UNITED STATES
NUCLEAR REGULATORY COMMISSION
WASHINGTON, D. C. 20555

SURRY POWER STATION UNIT NO. 1

Amendment No. 19
License No. DPR-32

SAFETY EVALUATION BY THE OFFICE OF NUCLEAR REACTOR REGULATION
SUPPORTING AMENDMENTS NO. 19 TO LICENSES NOS. DPR-32 AND DPR-37

Figure 1

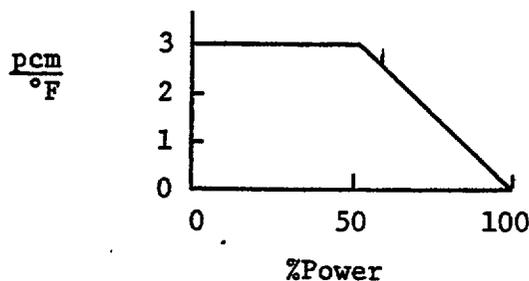
The Virginia Electric and Power Company has reexamined the accidents and transients presented in the Final Safety Analysis Report (FSAR) for sensitivity to a positive moderator coefficient. With the exception of the rod withdrawal from subcritical and rod ejection accidents all transients reanalyzed used a constant moderator coefficient of $+3 \text{ pcm}/^\circ\text{F}$ ($+0.3 \times 10^{-4} \Delta\text{K}/^\circ\text{F}$). This is conservative since, as shown in Figure 1, the coefficient is constant to 50% power and then decreases linearly to zero at 100% power.

The rod ejection accident was analyzed with a moderator coefficient which approaches zero (becomes less positive) with increasing power. The rod withdrawal from subcritical was analyzed in the FSAR with a moderator coefficient of +10 pcm/°F and therefore bounds the requested Technical Specification change.

The reanalyses indicate that the minimum departure from nucleate boiling ratio (DNBR) occurs for the rod withdrawal at power accident. A range of possible reactivity insertion rates was analyzed. The most limiting rate was found to be 2.3×10^{-5} ΔK/sec, which corresponds to the point of intersection of the overtemperature ΔT and high neutron flux trip curves. This value of reactivity insertion rate yields a minimum DNBR of 1.32. Thus, the DNBR for all transients remains above the limiting value of 1.30.

1. Except during low power physics tests, the reactor shall not be made critical at any temperature above which the moderator temperature coefficient is more positive than:
 - a) +3 pcm/°F at less than 50% of rated power, or
 - b) +3 pcm/°F at 50% of rated power and linearly decreasing to 0 pcm/°F at rated power.
2. In no case shall the reactor be made critical with the reactor coolant temperature below DTT +10°F, where the value of DTT + 10°F is as determined in Part B of this specification.
3. When the reactor coolant temperature is below the minimum temperature as specified in E-1 above, the reactor shall be subcritical by an amount equal to or greater than the potential reactivity insertion due to primary coolant depressurization.
